A303 Amesbury to Berwick Down

**8.46 – Response to English Heritage objection to PRow to
Visitor Centre**

Response to English Heritage objection to PRow to Visitor Centre

Regulation Number:	Regulation 5(2)(q)
Planning Inspectorate Scheme Reference	TR010025
Application Document Reference	8.46
Author:	A303 Amesbury to Berwick Down Project Team, Highways England

OPTION D - UNCONTROLLED CROSSING. COLOURED SURFACE TO HIGHLIGHT THE APPROACHES

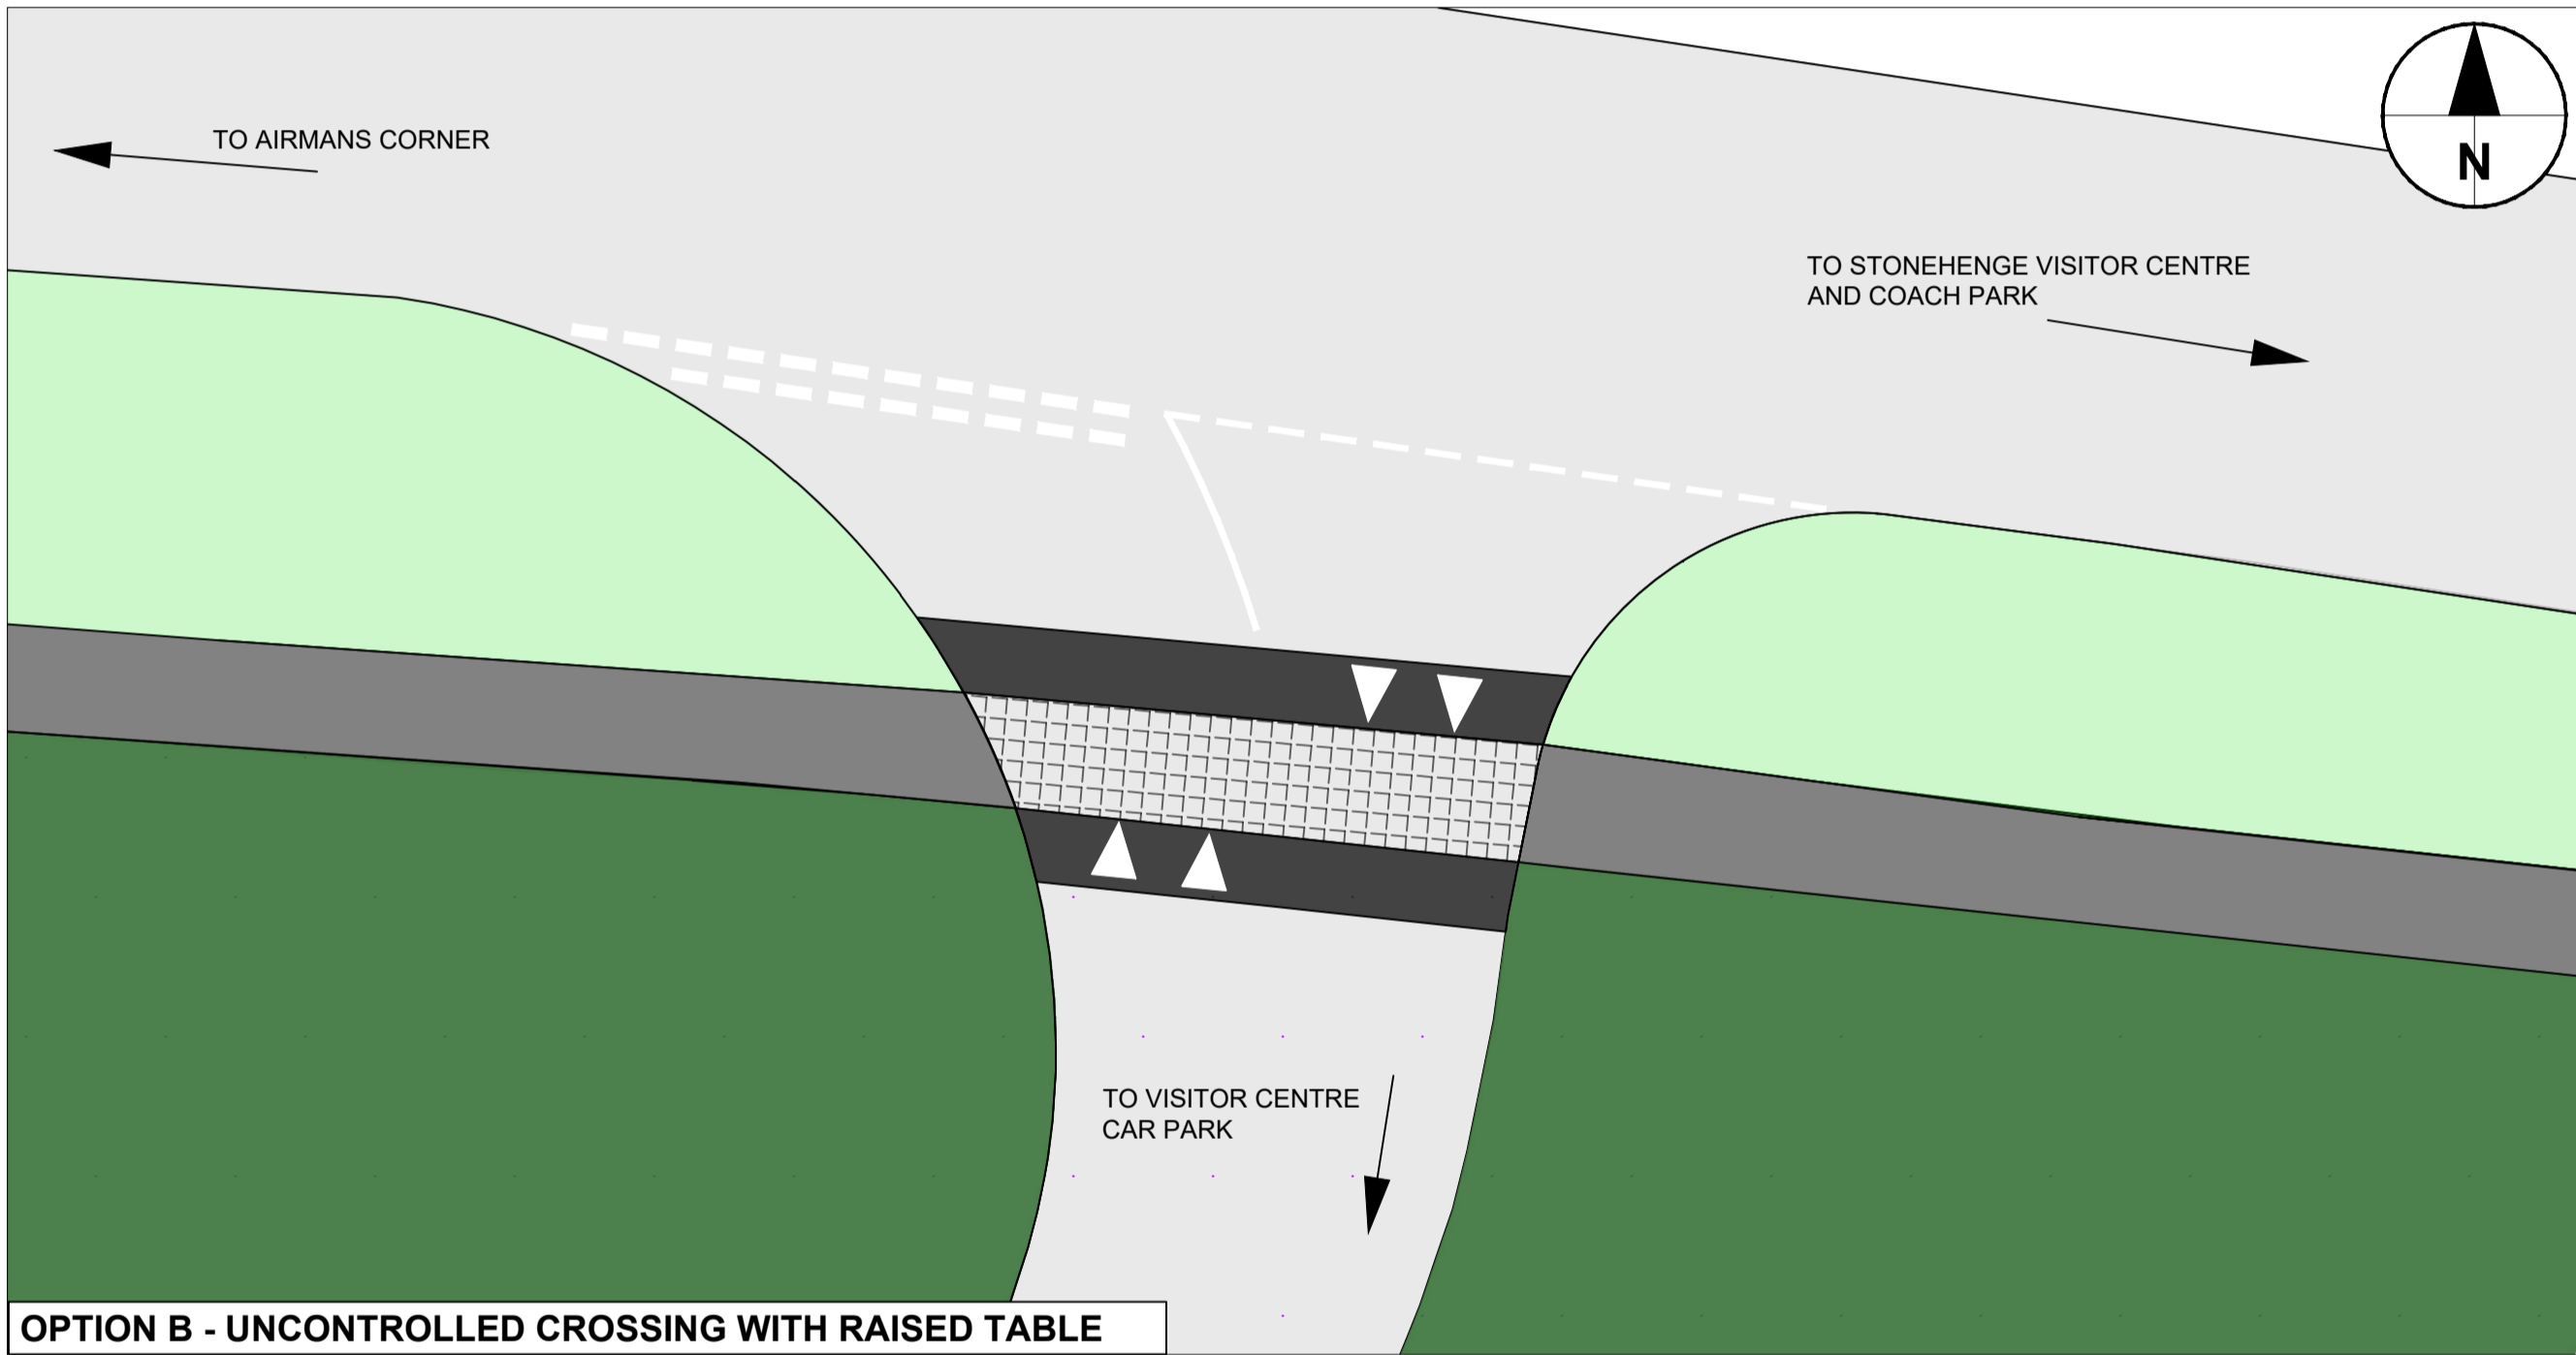
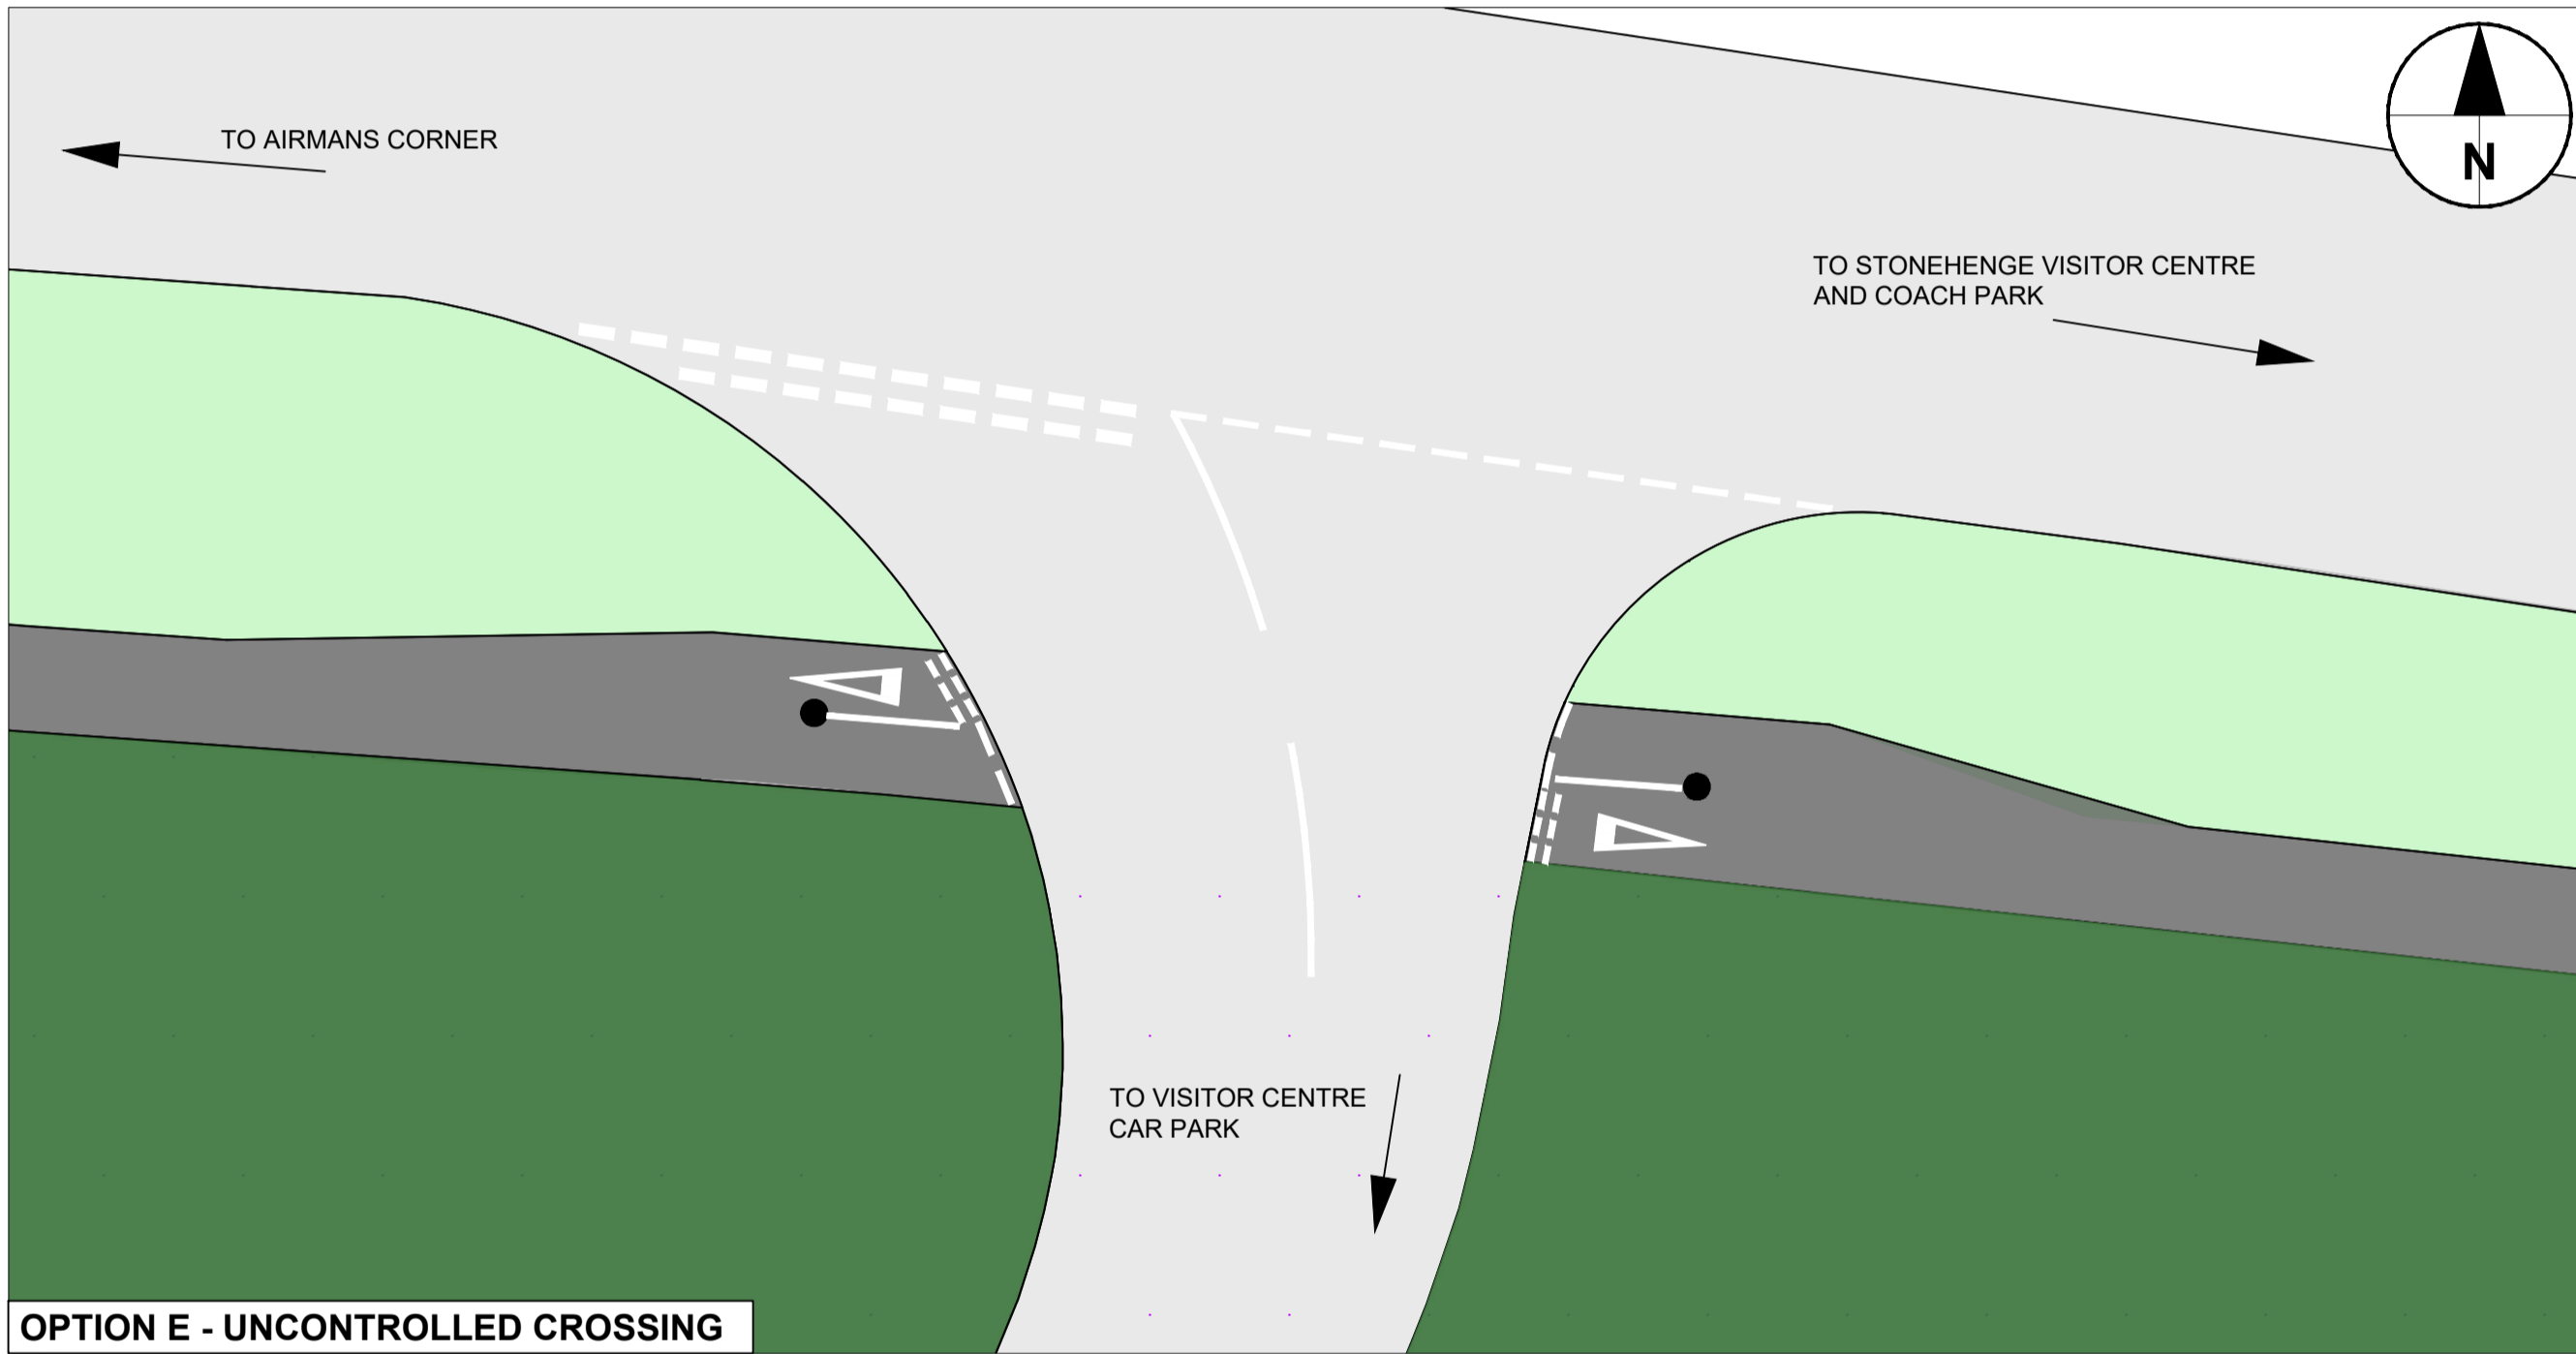
- 7.3.3 At the car park access road crossing, a number of options have been developed. Each one gives priority to the vehicles entering the car park. These options are illustrated in drawing No HE551506-AMW-ENM-SW_GN_000_Z-SK-CH-0017. See Appendix 3 to this report.
